**BOARD OF ZONING ADJUSTMENT  
STAFF REPORT****Date: September 9, 2013****CASE NUMBER**

5855

Pala Verde-CWB, LLC/ Pala Verde-DWB, LLC

**VARIANCE REQUEST****SURFACE:** Surface Variance to allow outdoor RV, boat and auto storage on a aggregate surface in a B-3, Community Business District**ZONING ORDINANCE  
REQUIREMENT****SURFACE:** The Zoning Ordinance requires vehicle and boat parking and storage surfaces to be paved with asphalt, concrete, or an approved alternative paving surface in a B-3, Community Business District**ZONING**

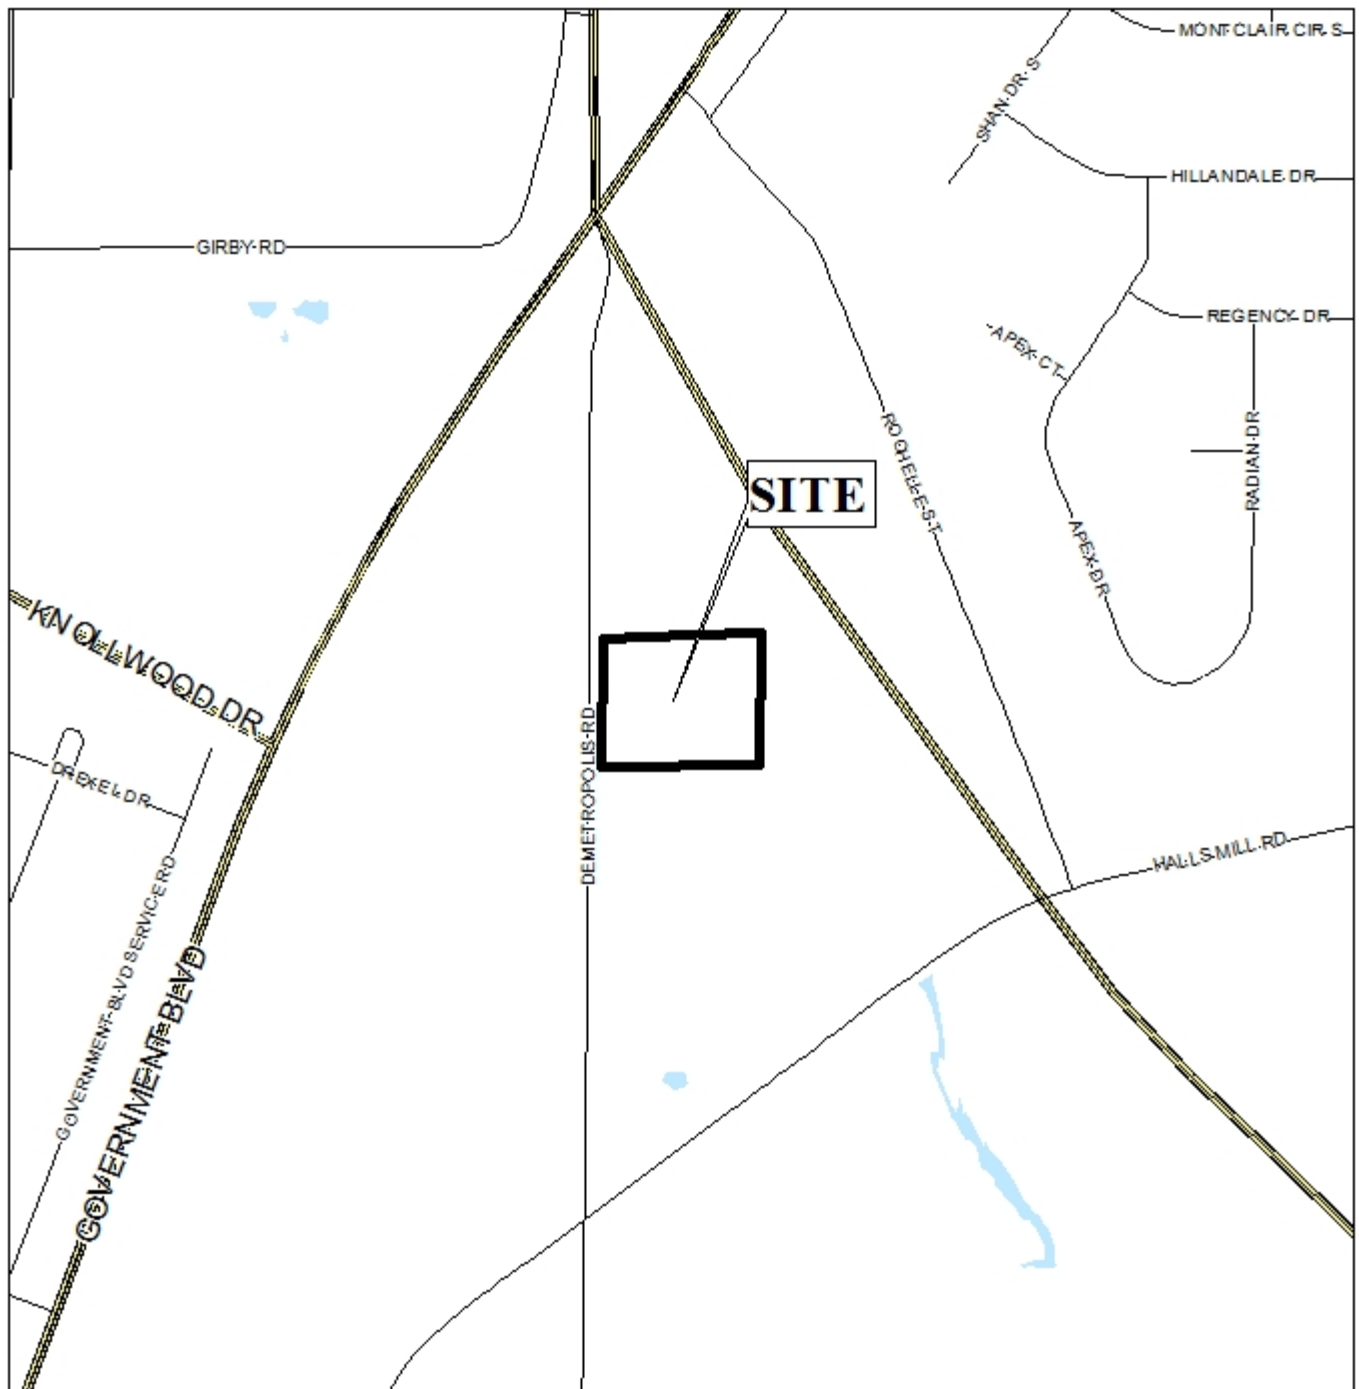
The surface of all driving and maneuvering areas is required to be paved with asphalt, concrete or an approved surface (Mobile City Code, Chapter 64, Section 64-4). The Engineering Department did not receive any request to review an alternate surface.

- 3) According to the FEMA flood map information, this property is located within a Special Flood Hazard Area (X-shaded and AE) and Floodway. You will need to show and label

the flood hazard area(s) and Floodway on your plat and plans. No work is allowed within the Floodway. Calculations are required for any work within the SFHA.

The site is undeveloped and a portion of the property is located in an AE flood zone, X shaded flood zone, and a floodway. All maneuvering and parking surfaces for the site, other than the driveway and a portion of the main entrance drive, are proposed to be limestone. Based on the location of the site and its close proximity to Spring Creek if a flood were to occur or continuous rain fall caused the creek to overflow it is possible that excessive water would remove and displace the proposed aggregate paving.

Aggregate paving is not an ideal surface because of the possibility of the surface to shift or to be transported via tires onto the right-of-way and adjacent properties; and because parking surfaces are not readily delineated. Also over time, compaction causes the aggregate to no longer be pervious, and without sufficient detention facilities provided, it creates not only a run off problem, but the dust and sediment included in the run off exacerbates the problem. While the

limestone surface would allow for the maneuvering and parking of heavy vehicles, and assuming such vehicles are capable of traveling on standard paved public streets, there is nothing that should prevent the vehicles from maneuvering and parking on a compliant surface within the subject site. As previously mentioned, all maneuvering and parking surfaces for the site, other than a portion of the driveway and main entrance drive, are proposed to be limestone. Thus it can easily be provided for the entire site. There is nothing which should prevent standard cars, RV's, or boats from utilizing compliant paved and delineated parking surfaces.

It should also be noted that a site plan was submitted with tree and landscaping calculations. Although there is no variance request for tree and landscaping requirements the plan has been reviewed by staff for compliance. Two additional understory parking trees will be required in order for the site to be in compliance. If the surface variance is approved revisions to the site plan will be required prior to any issuing of permits.

If the Variance is approved the following conditions should be added:

- 1) Before beginning any work on this site a Land Disturbance Permit must be submitted and approved. Any and all proposed development will need to be in conformance with the Storm Water Management and Flood Control Ordinance (Mobile City Code, Chapter 17, Ordinance #65-007 & #65-045); the City of Mobile, Alabama Flood Plain Management Plan (1984); and, the Rules For Erosion and Sedimentation Control and Storm Water Runoff Control.

- 2) The driveway/entrance from Demetropolis Rd, and any other work within the Demetropolis Rd ROW, including driveway, curbing, sidewalks, utility connections, grading, drainage, irrigation, or landscaping will require a ROW permit from the City of Mobile Engineering Department (208-6070) and must comply with the City of Mobile Right-of-Way Construction and Administration Ordinance (Mobile City Code, Chapter 57, Article VIII).

Based on the preceding, the surface variance request is recommended for denial.
